INITIAL FIRE SAFETY INSPECTION REPORT

SP Washing Ltd.

RSC ID: 24814

Date: 10 January 2024

F-5

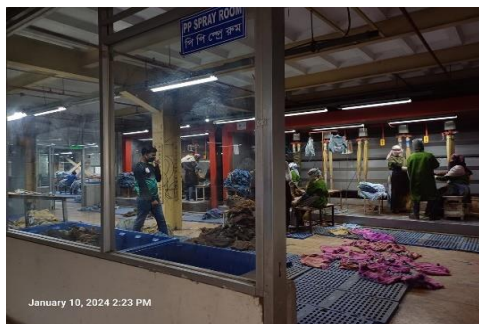
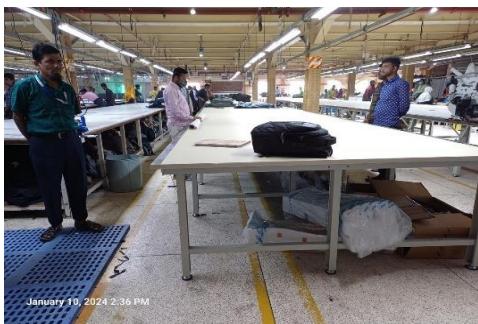
Hazardous materials / flammable storage area is not properly separated by fire-rated construction due to openings & penetrations.
Location: Main Building (Ground floor), Acid tank of 3000 liter beside the Main Building, Chemical Store Shed.

Hazardous materials / flammable storage shall be in compliance and separated in accordance with BNBC 2006 Part 3 Section 2.13 and Table-3.2.1.
